VILLAGE REVIEW BOARD

AGENDA

COUNCIL CHAMBERS, 85 UNION STREET
THURSDAY, JANUARY 22, 2015, 6:30 P.M.

**Draft Findings of Fact
Certificate of Appropriateness
Village Review Board
Review Date: January 22, 2015**

ANNE RUTHSDOTTIR
29 SCHOOL ST
APT. PORCH ENCLOSURE

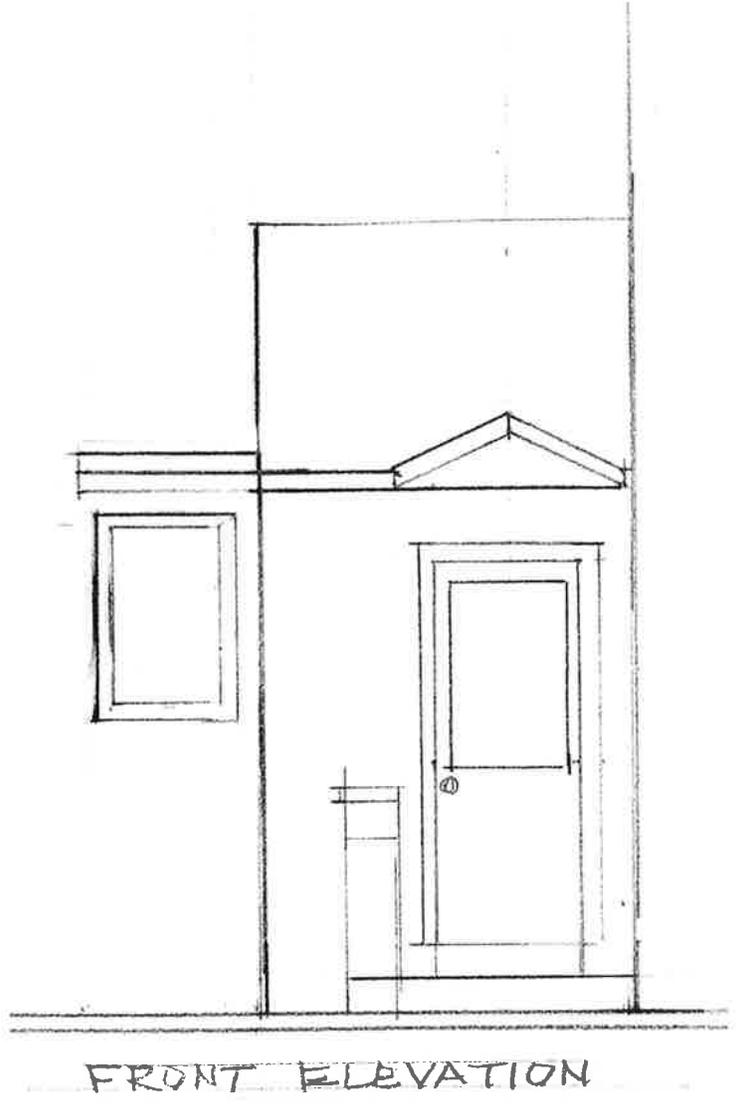
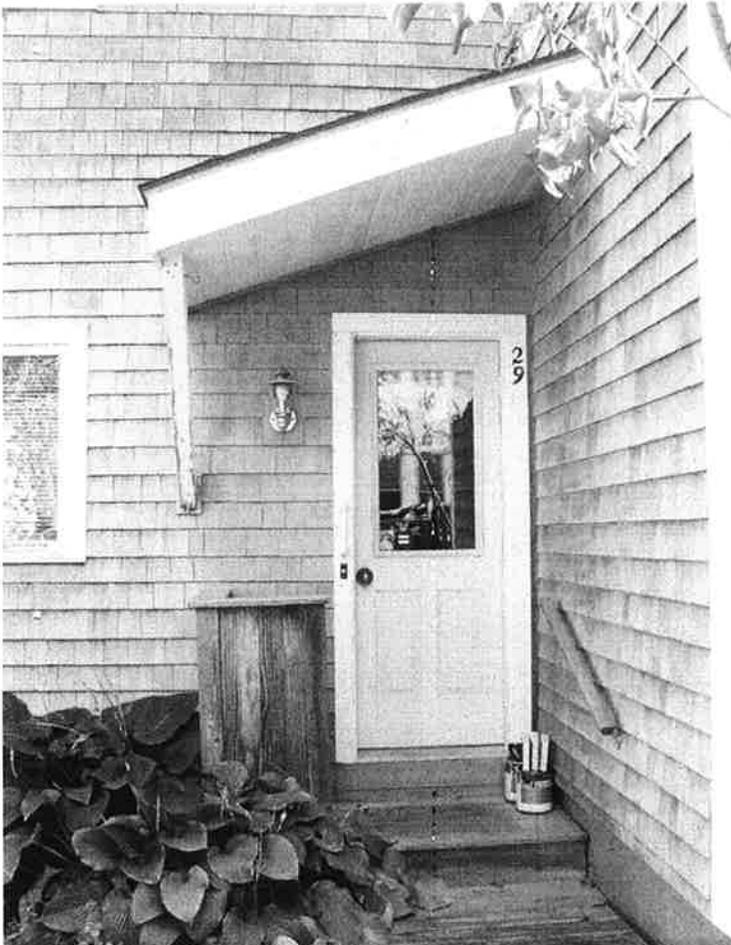
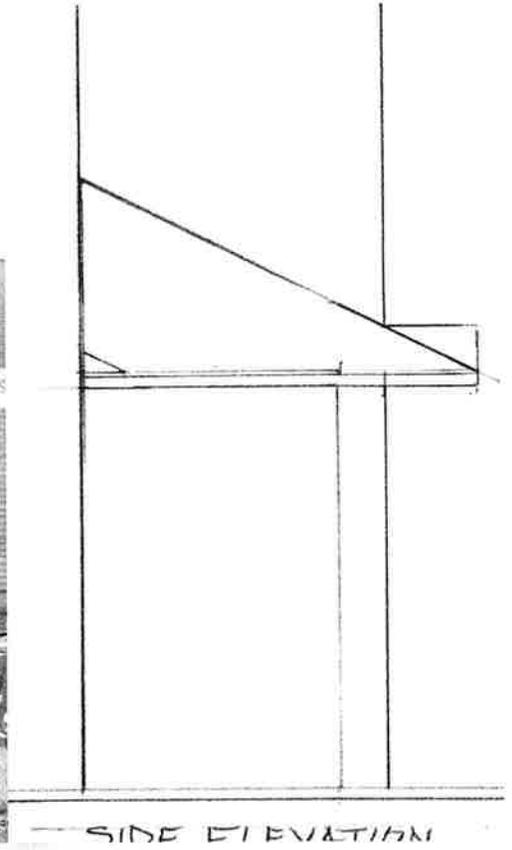
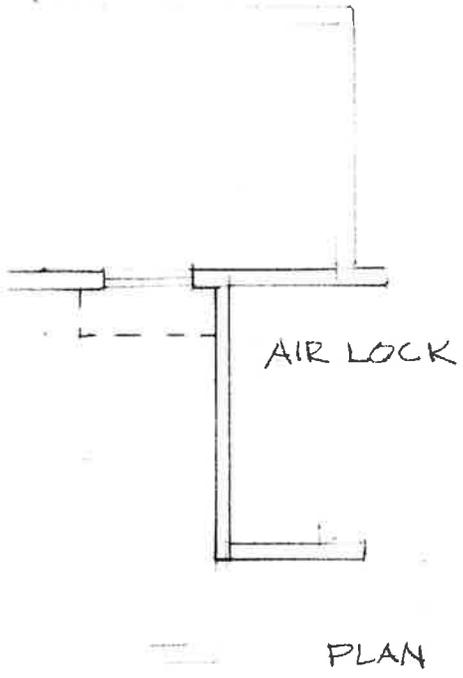
The remaining two air lock entries will fully enclose small entry porches located to the rear on either side of the structure, not visible from the street. Additional roofline improvements will be made as part of the proposed west side air lock addition, per attached photos and drawings.

VRZ Design Guidelines note that existing porches and character-defining features should be maintained and preserved. Further, enclosing an existing porch on the primary building façade should be avoided. It appears that the applicant has made an effort to minimize the porch enclosure as much as possible and is maintaining and preserving all character-defining features.

1 SOUTH (LINCOLN ST.) ELEVATION
 1/4" = 1'-0"

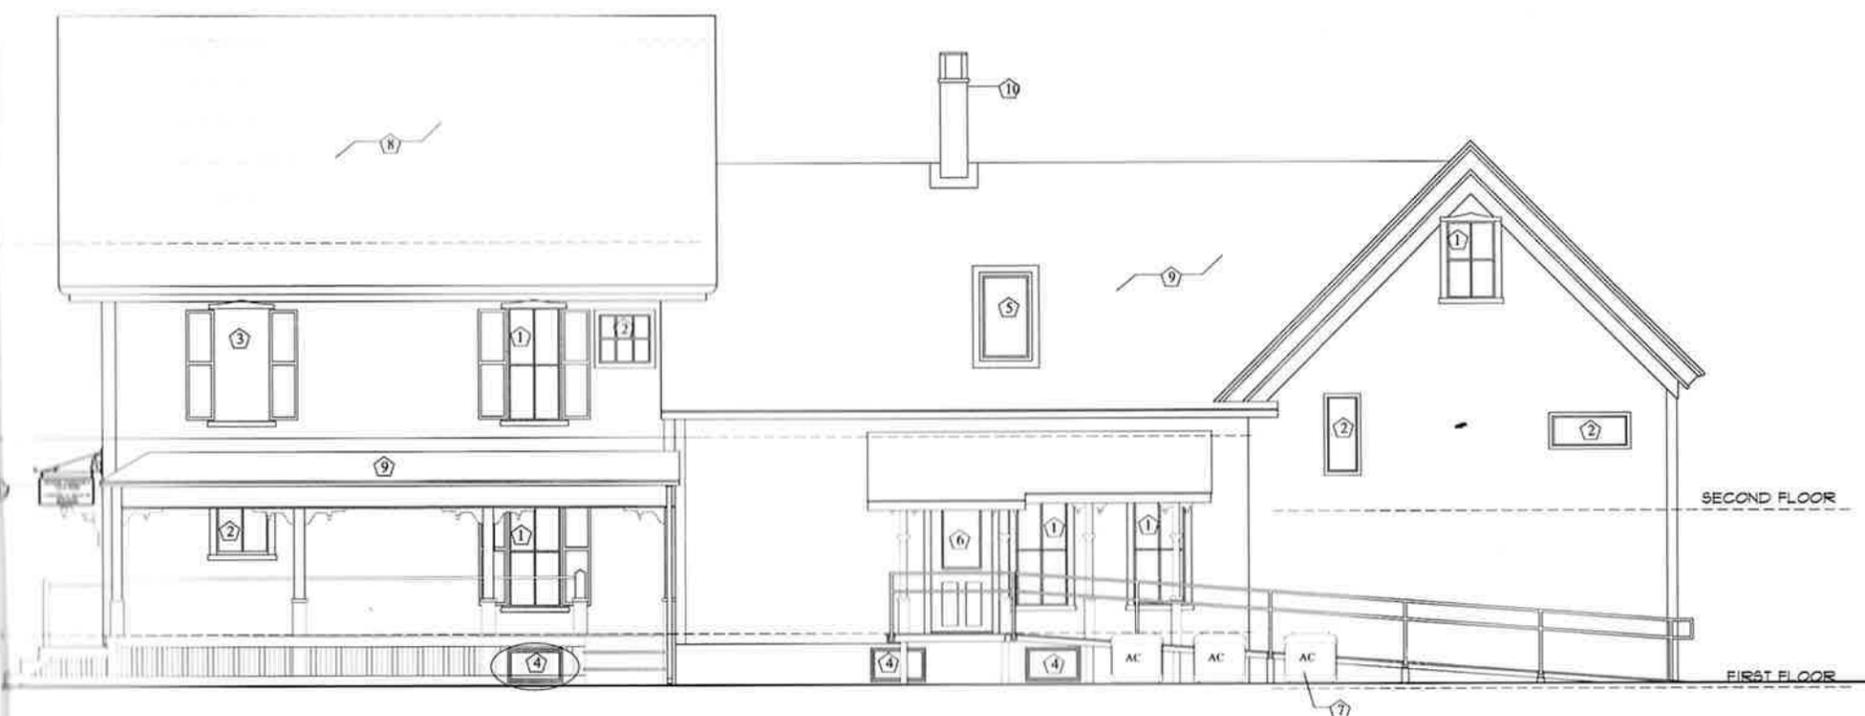
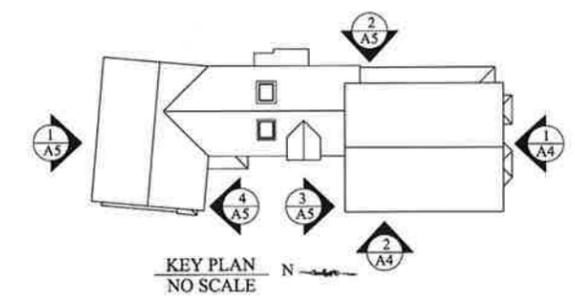
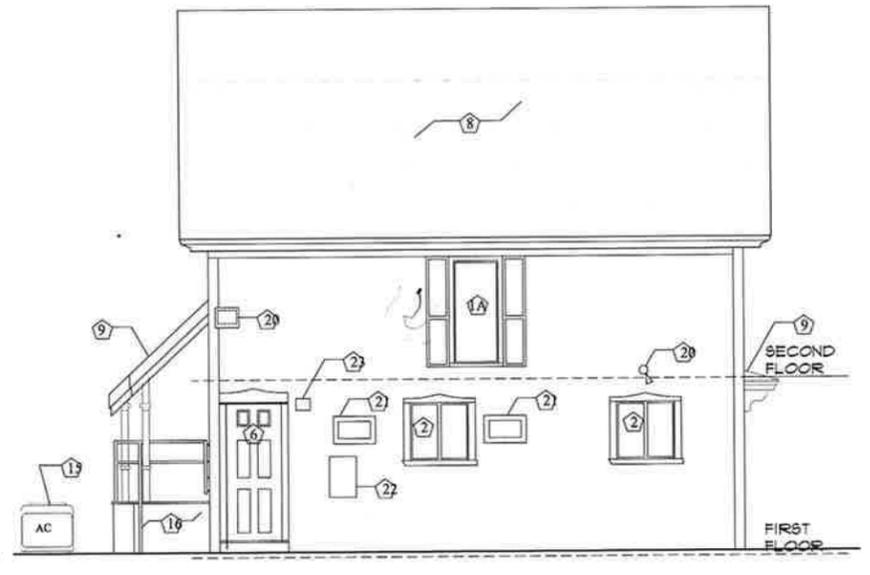
- b. *As stated in the VRZ Design Guidelines, "every reasonable (emphasis added) effort should be made to maintain and preserve a property's historic windows." The applicant is proposing to replace all 21 double-hung, two over two wood windows, and one larger double-hung window facing the parking lot, with energy efficient vinyl clad replacements to fit the same openings and of same style. Exterior and interior trim and shutters will not be removed or altered. As pointed out, other structures have vinyl-replacement windows, although no application requests were found for the properties noted. However, as noted previously in other applications, vinyl-clad replacement windows of the same size and style as those being replaced have been found as acceptable to the Board. It should also be noted that several casement windows are preexisting, primarily on the ell section of the structure.*

- d. *Relocate the existing sign bracket and sign. Sign replacements are handled at the staff level. There is no change in size or style of the existing sign. Placement is consistent with other hanging signs on Lincoln Street.*

Building Elevation

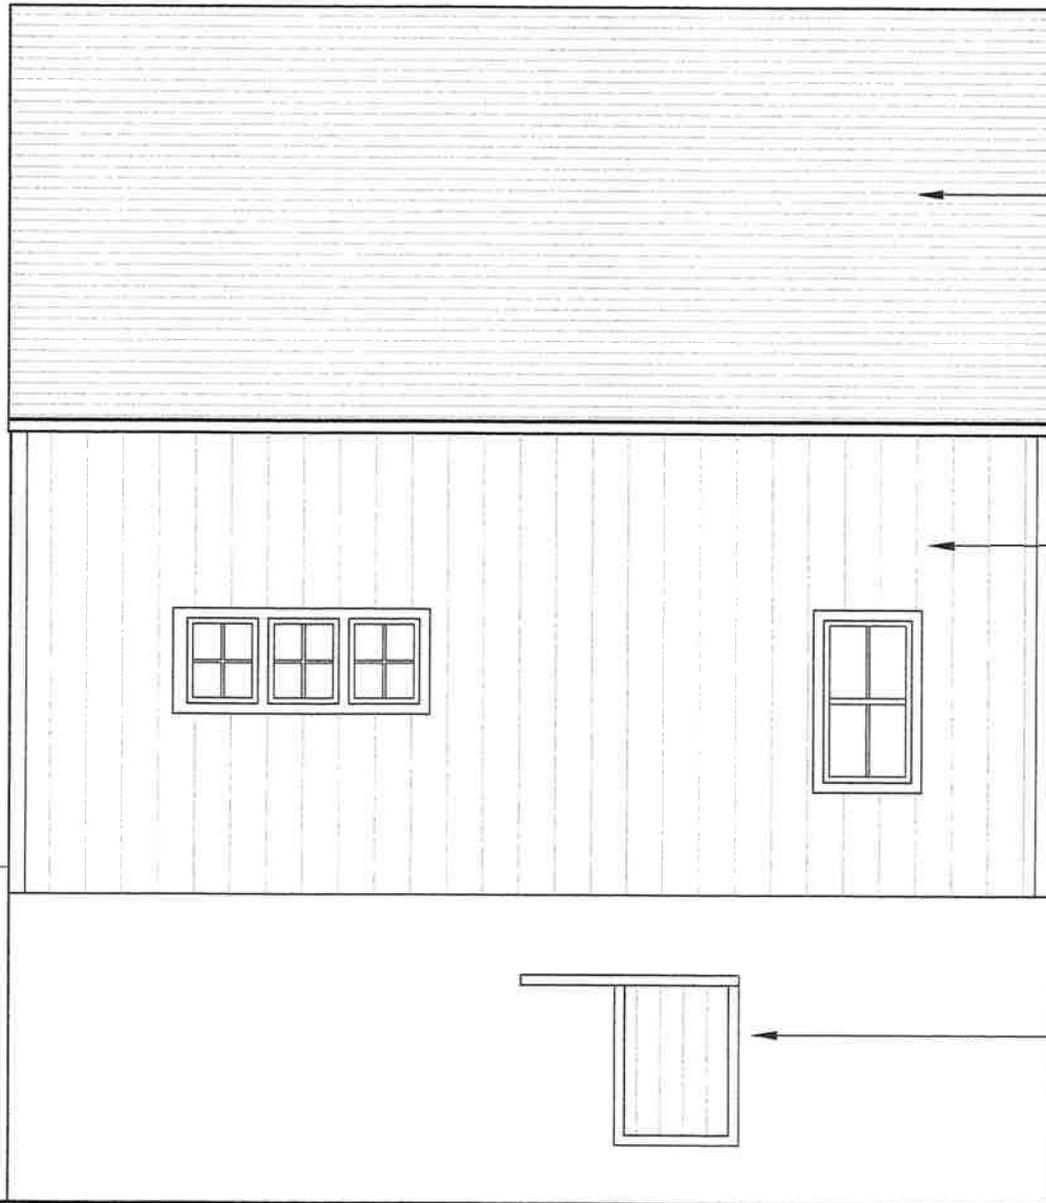
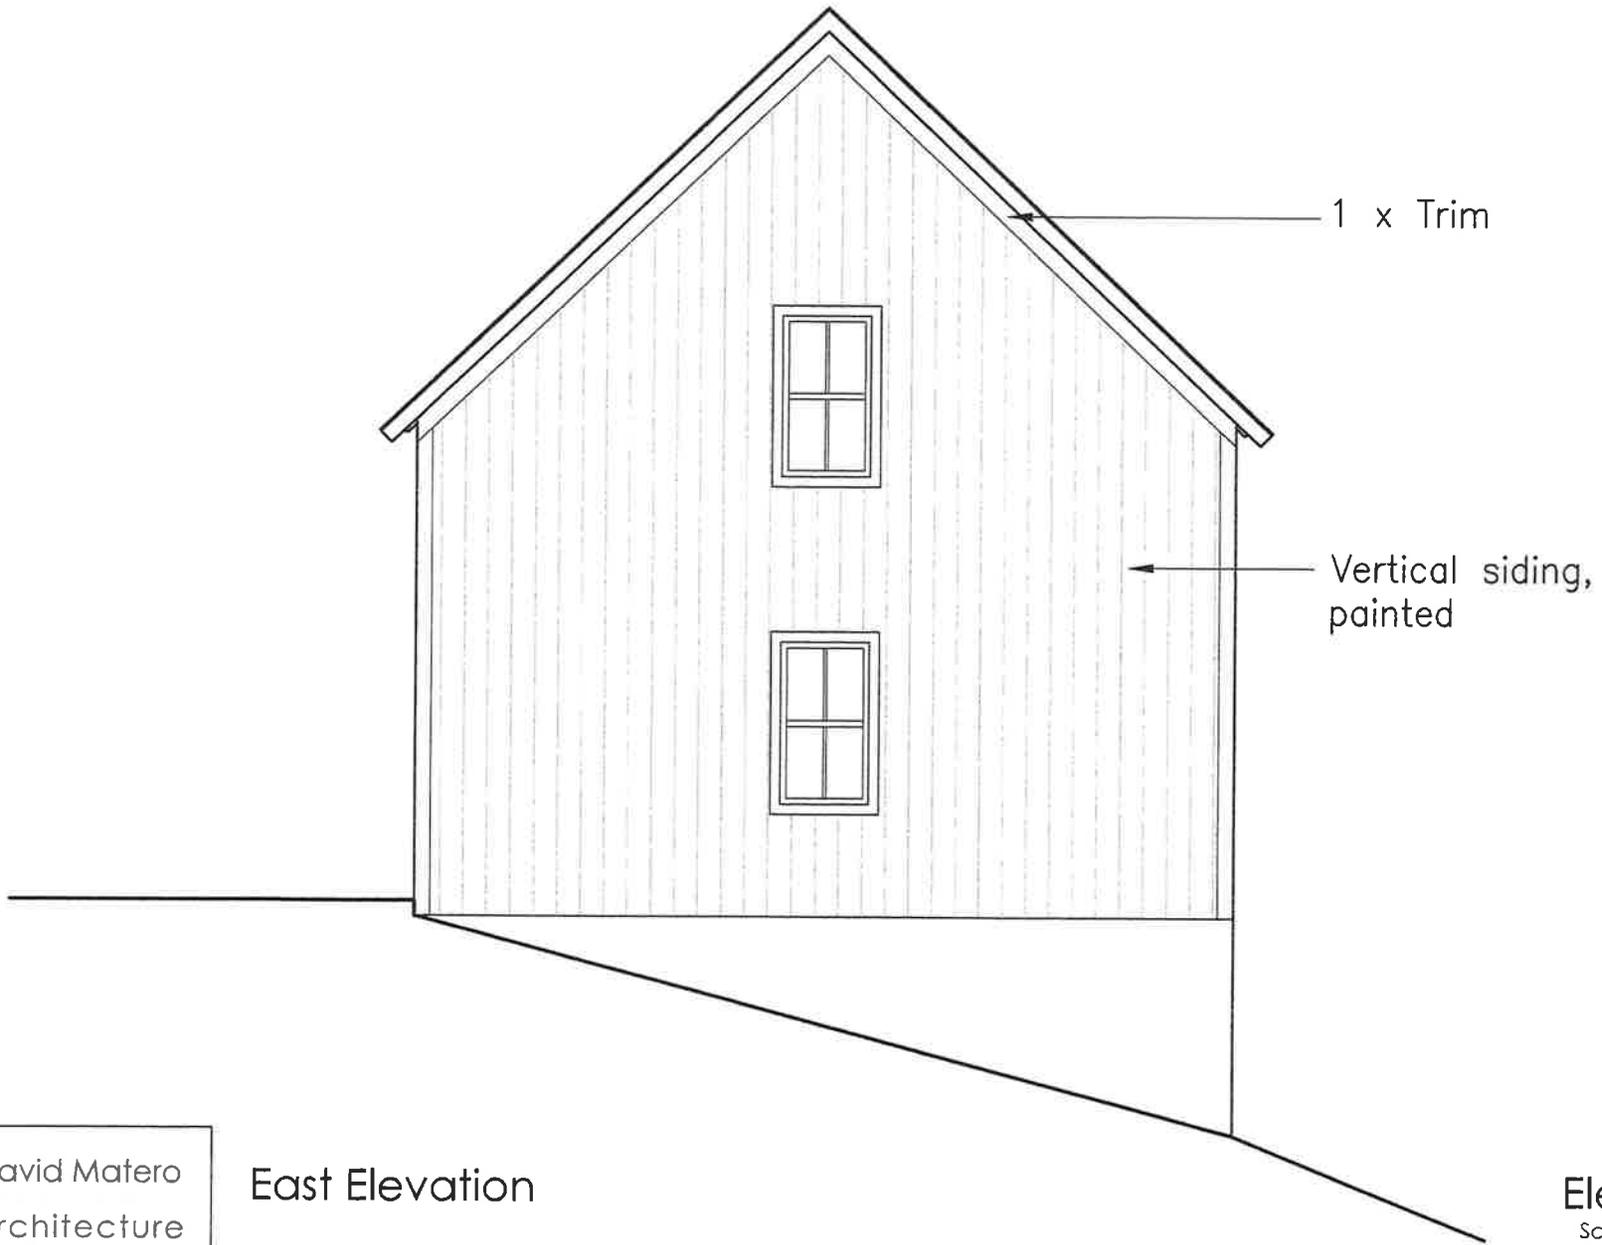
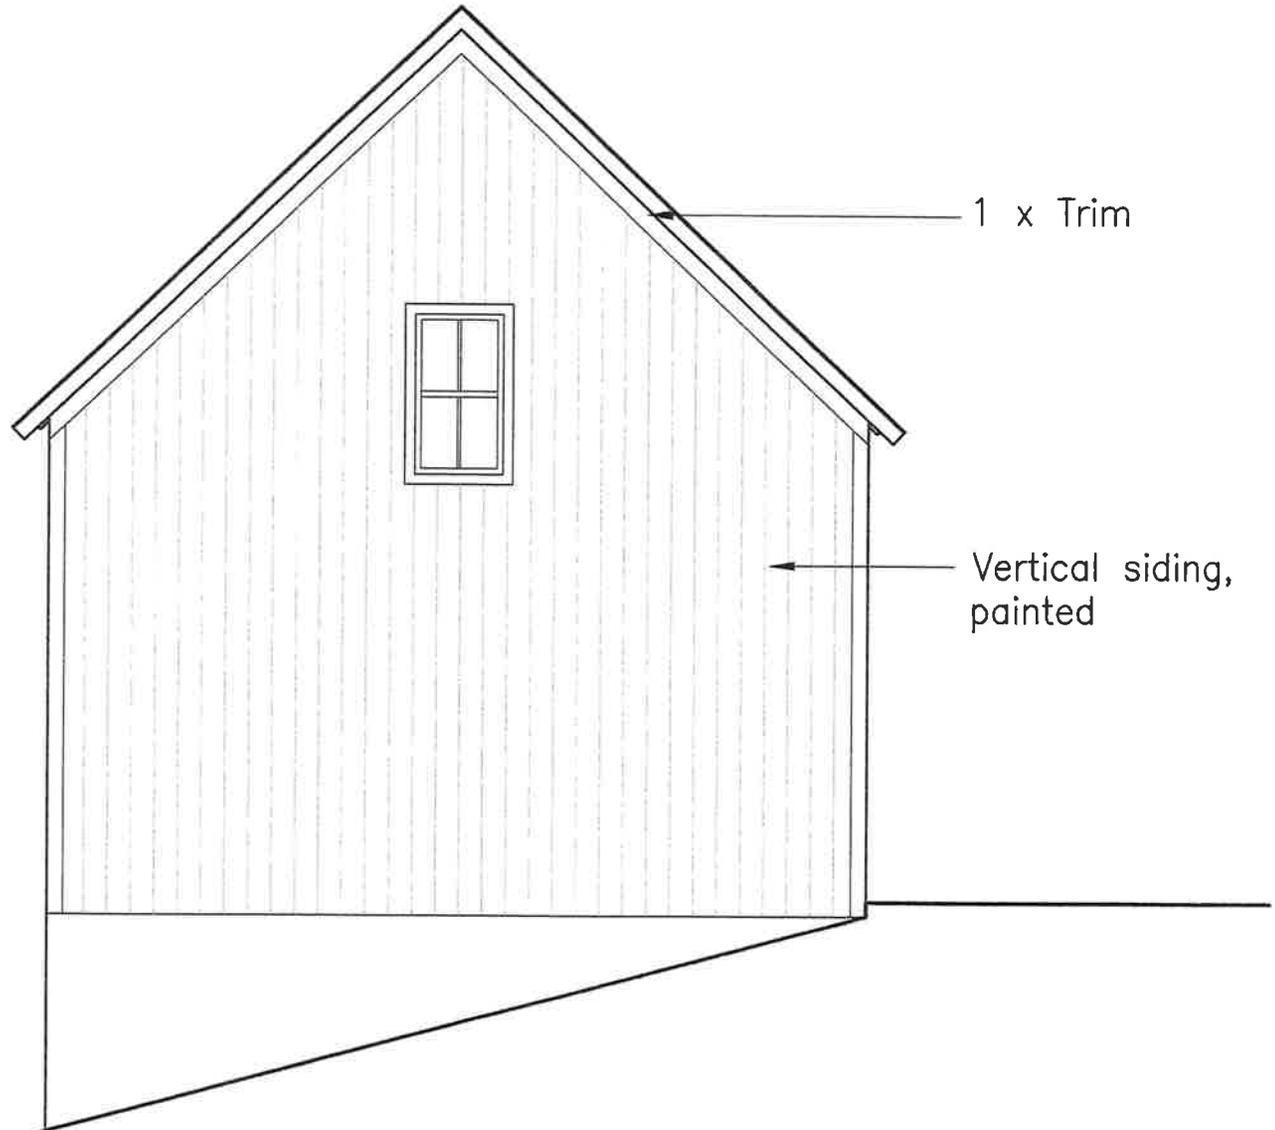
The existing barn's exterior features appear to have been altered considerable over time (removal of original windows, alterations to south-facing façade). The applicant is proposing to replace the existing (deteriorated) shingle siding on the barn's north, east, and west sides, and the existing clapboard siding on the south side, with #2, 1x10 vertical shiplap pine siding. The siding will be painted, although a color has not yet been determined. Two new steel insulated doors will be installed on the south façade. The existing windows consist of rough openings with storm windows screwed over them, and are proposed to be replaced with vinyl windows. Lastly, the applicant is proposing to extend the roof line (and shingling) over the south façade by a few feet, to shed water away from barn.
